## RESPONSE TO REQUEST FOR ADDITIONAL INFORMATION

### APR1400 Design Certification

Docket No. 52-046

RAI No.: 202-8206  
SRP Section: 08.01 – Electric Power – Introduction  
Application Section: 8.01  
Date of RAI Issue: 09/08/2015

Figure 8.1-1 Electric Power System Single Line Diagram (Division I) (1 of 2)

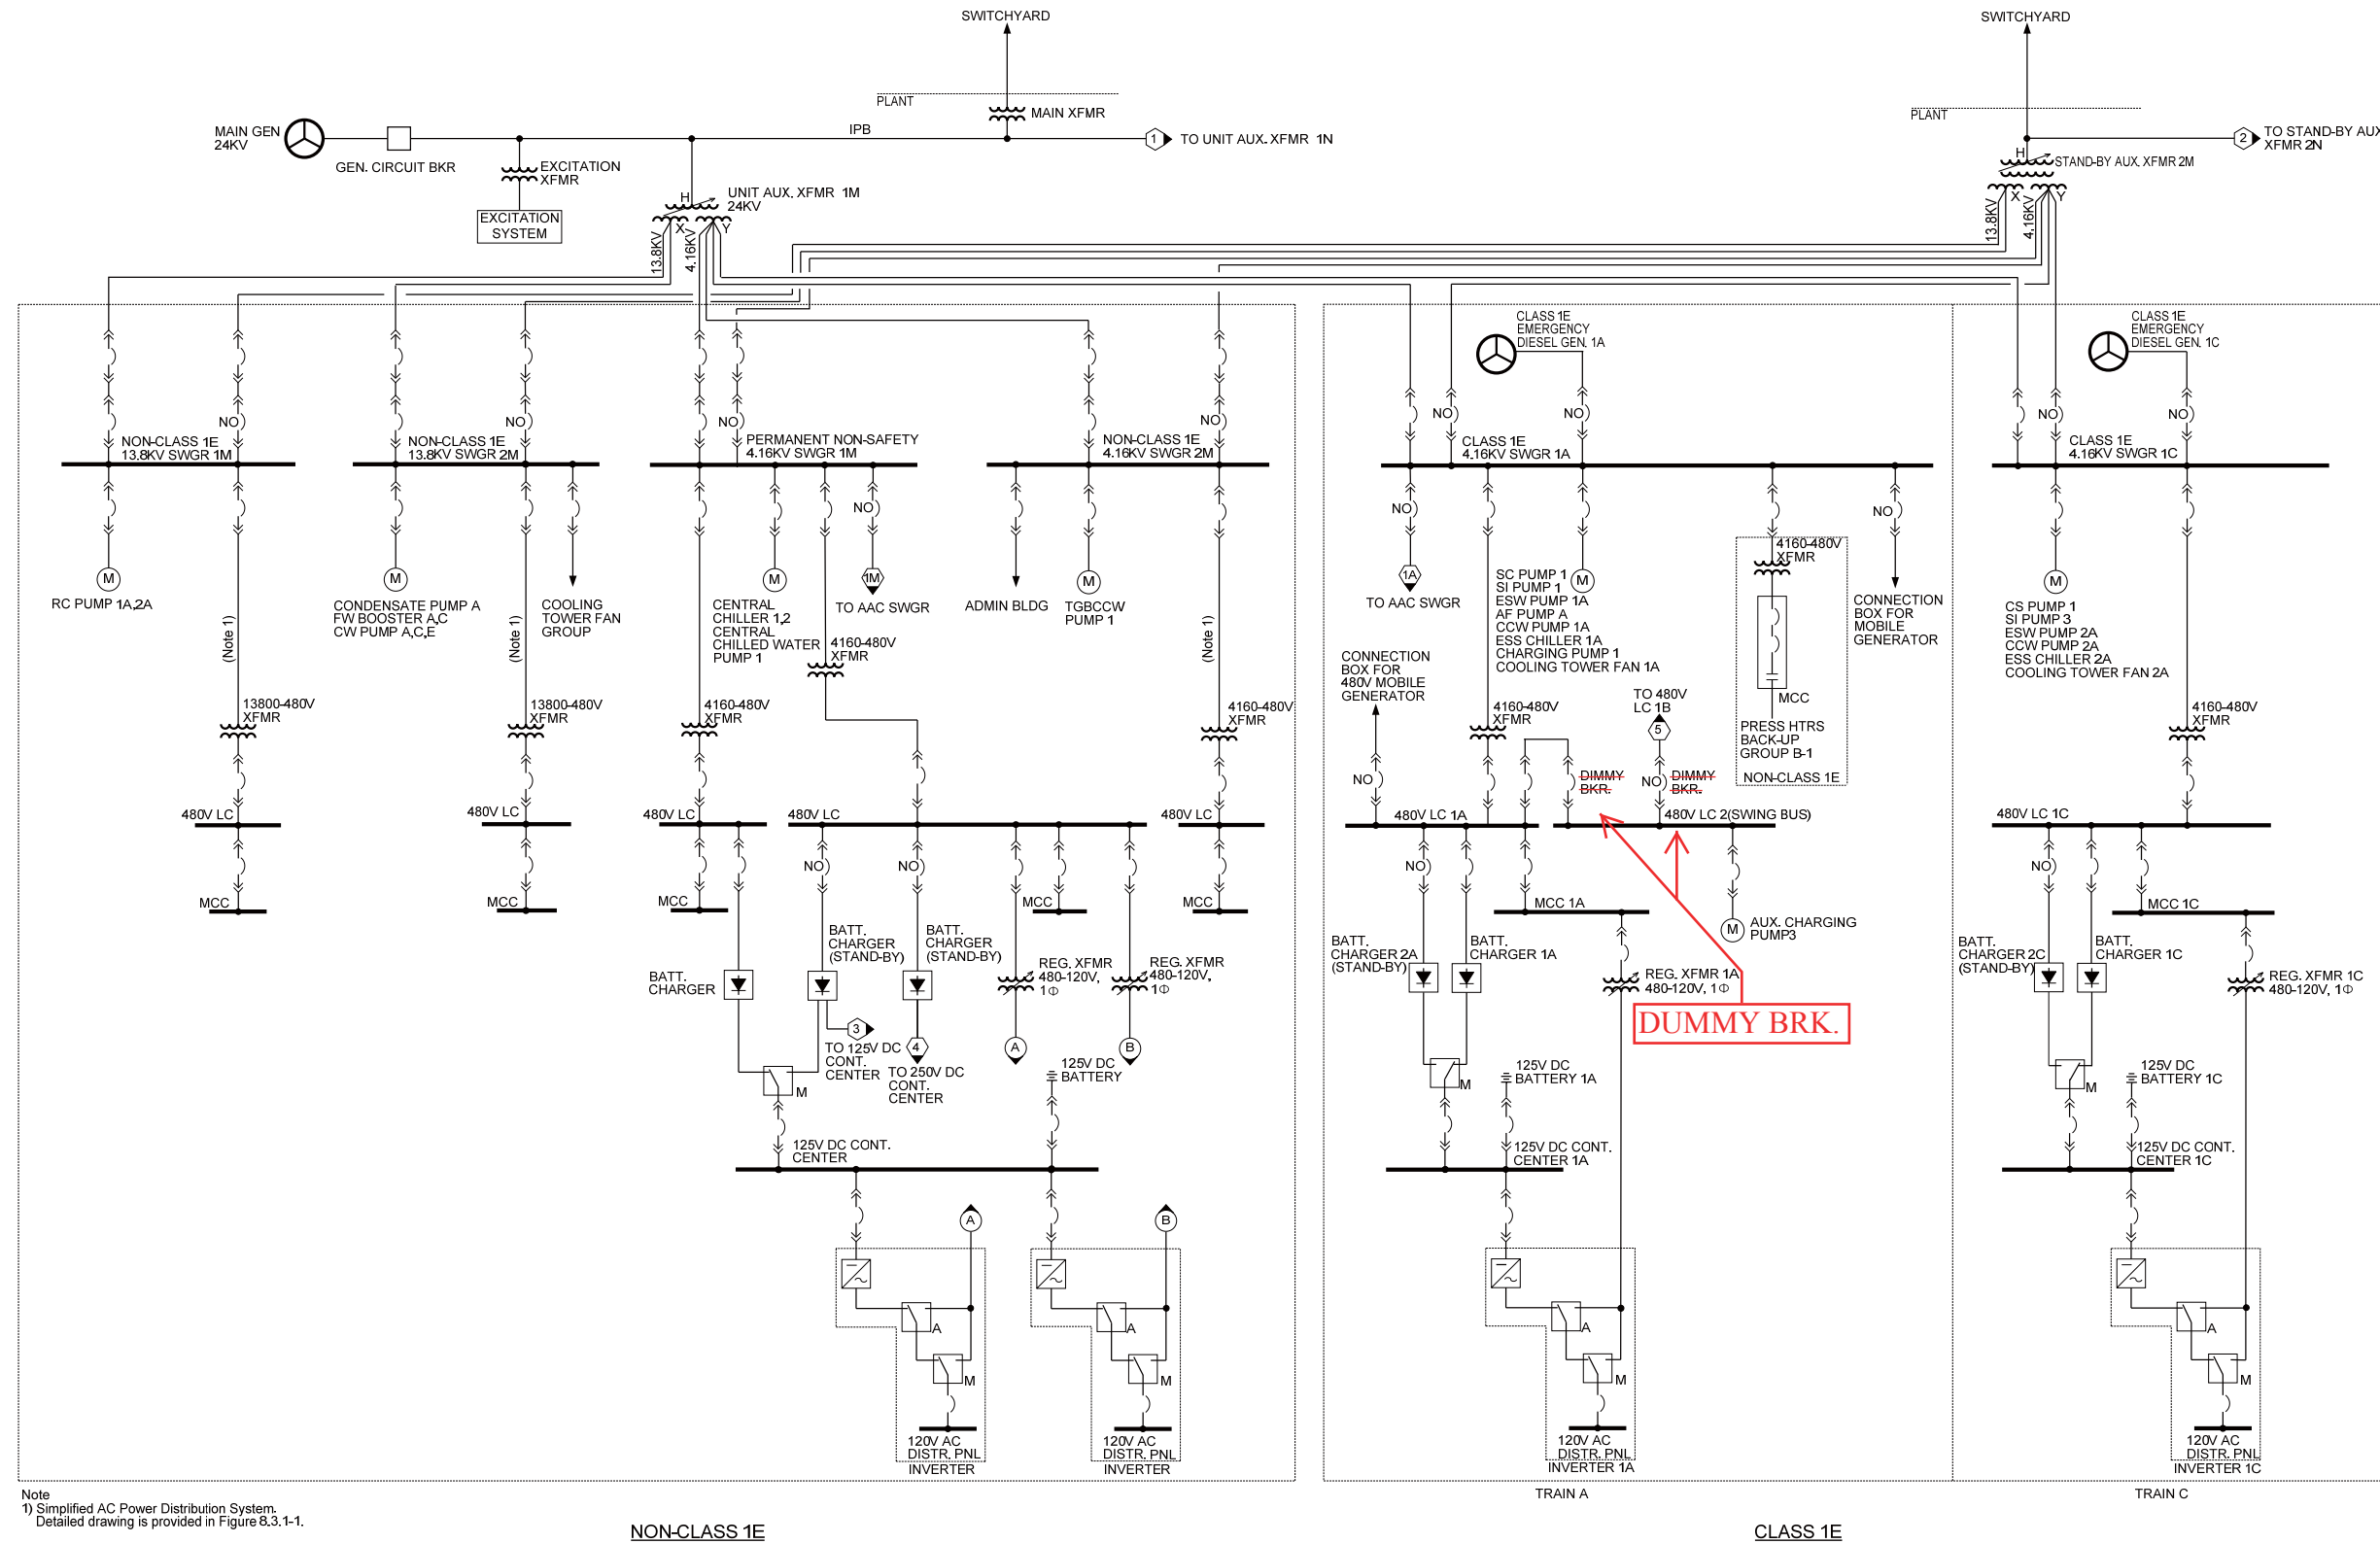
APR1400 DCD Figure 8.1-1, “Electric Power System Single-Line Diagram,” identifies “DIMMY” breakers in the Class 1E 480V load center (LC) 1A and LC 2. However, DCD Figure 8.3.1-1, “Onsite AC Electrical Power System,” identifies “DUMMY” circuit breakers. DCD section 8.3.1.1.2, “Class 1E Onsite AC Power System,” also states in part that in case of a loss of power from LC01A, LC02 is manually transferred to the train B load center (LC01B) through a dummy breaker. Please clarify the discrepancy between Figures 8.1-1, Figure 8.3.1-1 and section 8.3.1.1.2 related to the type of breaker used.

“DIMMY BKR” is a typographical error and should be “DUMMY BRK.” KHNP will change the term “DIMMY BKR” to “DUMMY BRK” in DCD Tier 2, Figure 8.1-1 (1 of 2).

DCD Tier 2, Figure 8.1-1 (1 of 2) will be revised as shown in the Attachment.
